Brookline Preservation Commission Local Historic District Report

Local Historic District: Cottage Farm

Address: 78 Powell Street

Proposed Alterations: The applicant proposes to construct an approximately 15' 6" by 19' 2" roof deck and install two single pane, true divided lite windows and French door (for deck access) on the west (rear) elevation of the house. The new French door will include a wood shingle flare roof for increased overhang protection. The deck will be setback 1' 8" from the corners of the roof and will include a cedar painted railing.

Proposed roof deck

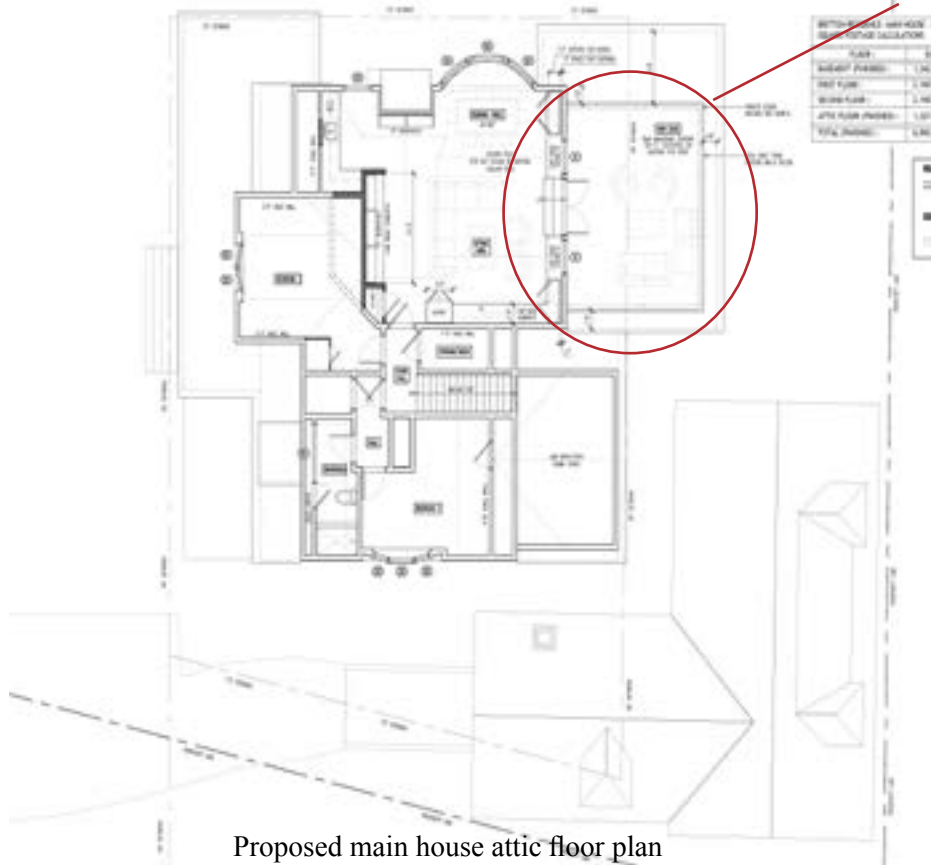
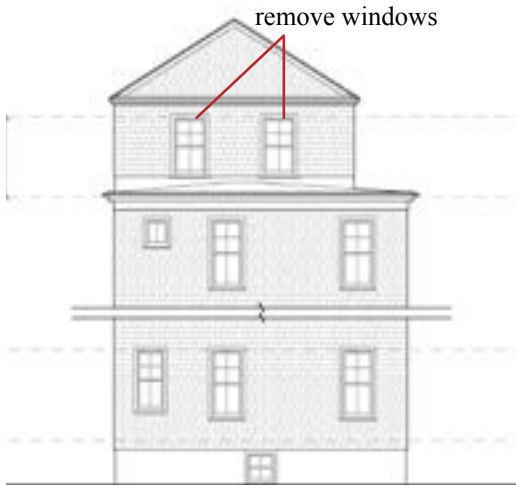
Preliminary Findings: The proposed main house roof deck is minimally visible from St. Paul Street and is unobtrusive to the streetscape. The carriage house addition is not on a primary elevation and is minimally visible from Freeman Street. The window changes on the north elevation are visible and a character defining element. Where possible staff recommends repair and reuse of the original wood windows rather than replacement in-kind.
